**ALTERATION TO A HISTORIC PROPERTY STAFF REPORT**

Site: 16 Westwood Road c.1911  
Case: HPC 2014.008 Westwood Road Local Historic District

Date of Application: February 26, 2014  
Legal Notice: *Add widow's walk, replace 3<sup>rd</sup> floor front windows and redesign second means of egress on rear.*

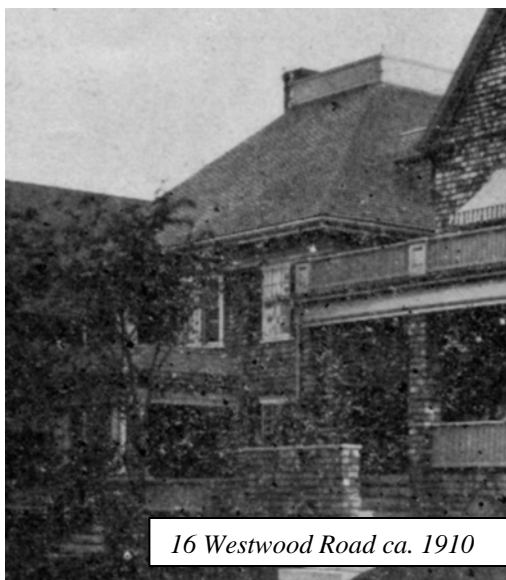
The widows walk would be replaced per the historic photo which is not highly detailed but does appear to have solid sides and urn-shaped posts with a finial of some sort.

The dormers on the side of the building are narrower than the front dormer and have double-hung windows. The proposal is to replace the sliding windows with double-hung windows on the front dormer in a style to be determined by the Commission. This was reviewed and approved by the Commission back in 1988, however, the details of the approved windows were not in the files but appears to have been 2/2 double-hung sash.

For the most part, the egress stairs will be essentially the same as the current ones with straight balusters instead of the lattice and a more traditional handrail. They have also proposed the addition of a roof which would extend over the back steps at an angle. A roof is required to shelter the egress door.

The replacement of the widow's walk will be in wood. It does appear to have either solid sides or simple balusters, and urn-shaped corner posts with a finial of some sort. The Applicant has suggested that it might be about 2 feet high.

**Staff recommends that the Historic Preservation Commission grant James Veneziano, Westwood Road Trust a Certificate of Appropriateness** for the reconstruction of the widow's walk *with the proportions and style shown in the historic photograph*; the replacement of the sliding glass windows in third floor dormer with double-hung 2/2 windows and *shutters to match those on the first and second floors and installed in such a way that they appear to be operable*; and the reconstruction of the second means of egress *with a small roof hood over the door and not extending over the stairs*.
